**Project No. 35077**

**Amendment No. 2**

**Generation Interconnection Agreement**

**AMENDMENT NO. 2**  
**TO GENERATION INTERCONNECTION AGREEMENT**

# **EXHIBIT "C-2"** **POINT OF INTERCONNECTION DIAGRAM**

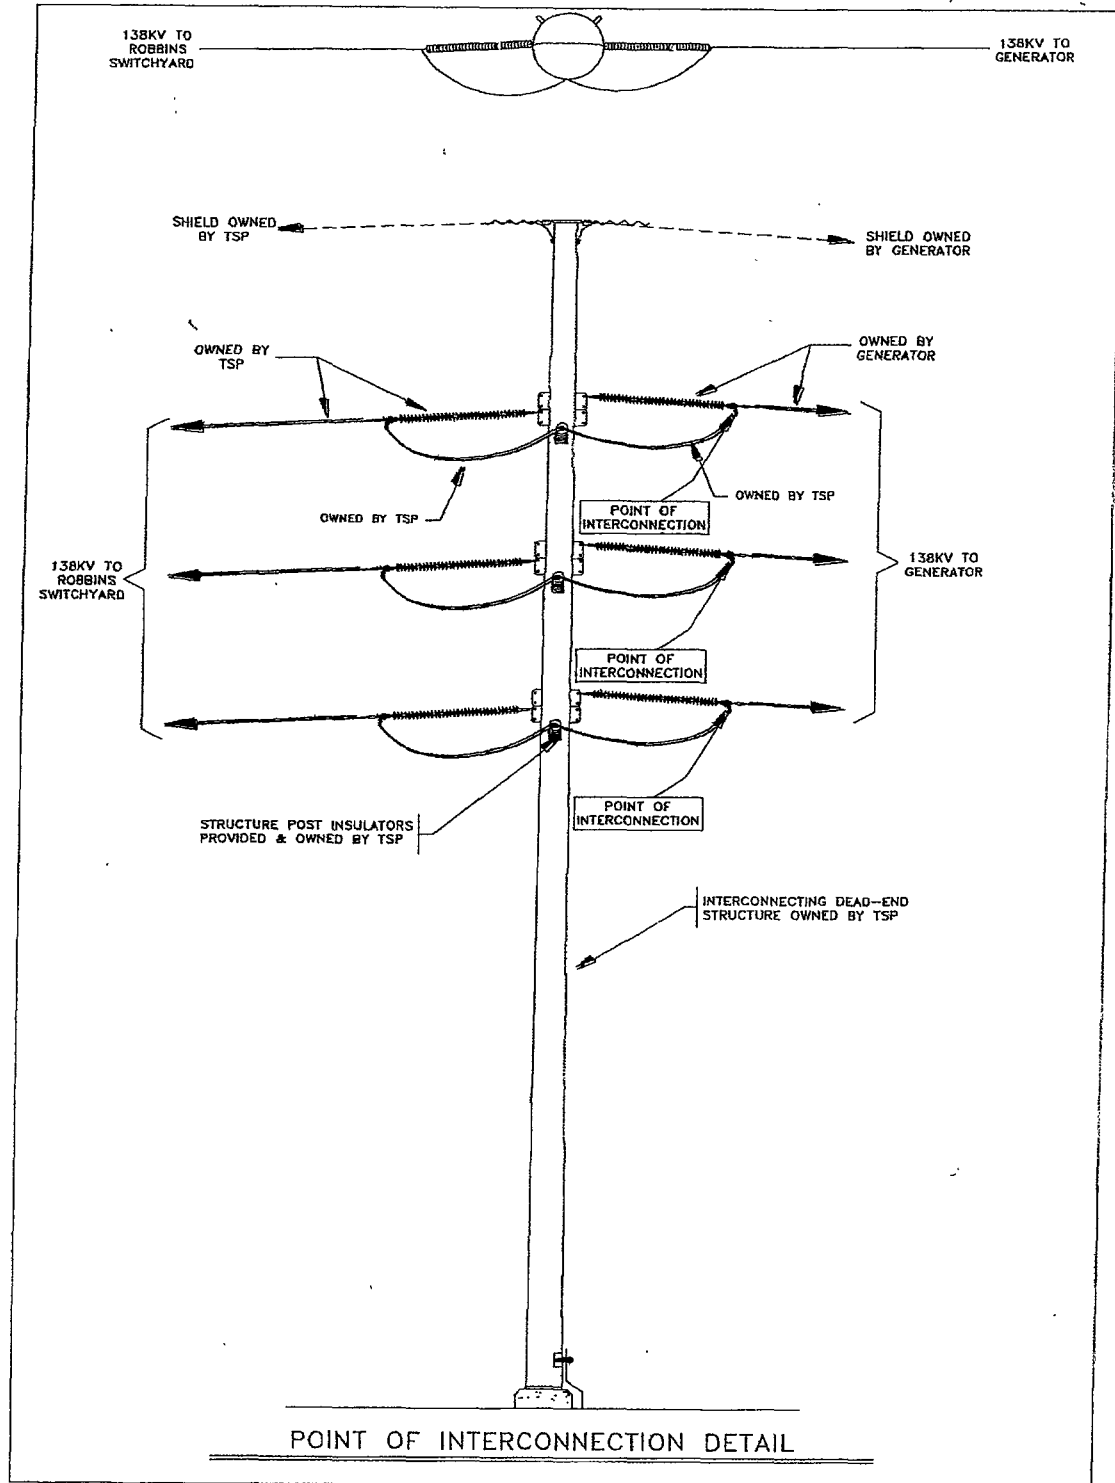
**WHEREAS**, this amendment to the Interconnection Agreement is necessary because the TSP will install 138-kV circuit breakers to increase transmission service reliability at the Robbins Switchyard and the description of the LCRA TSC Transmission Interconnection Facilities (TIF) requires updating; and

**WHEREAS**, the ERCOT Polled Settlement metering will be relocated from the plant to the TSP's new switchyard at Robbins Switchyard Substation.

1. Exhibit "C" Interconnection Details (including the diagrams Exhibit "C-1" and "C-2" attached thereto), attached to the agreement, is deleted in its entirety and Exhibit "C" Interconnection Details (including the diagrams attached thereto), attached to this Second Amendment, is hereby added to the Agreement in lieu thereof.

- (c) Three (3) 145-kV, 3000A circuit breakers in a ring-bus configuration
- (d) Six (6) 138-kV, 3000A VAB switches
- (e) Nine (9) 138-kV coupling capacitor voltage transformers "CCVTs"
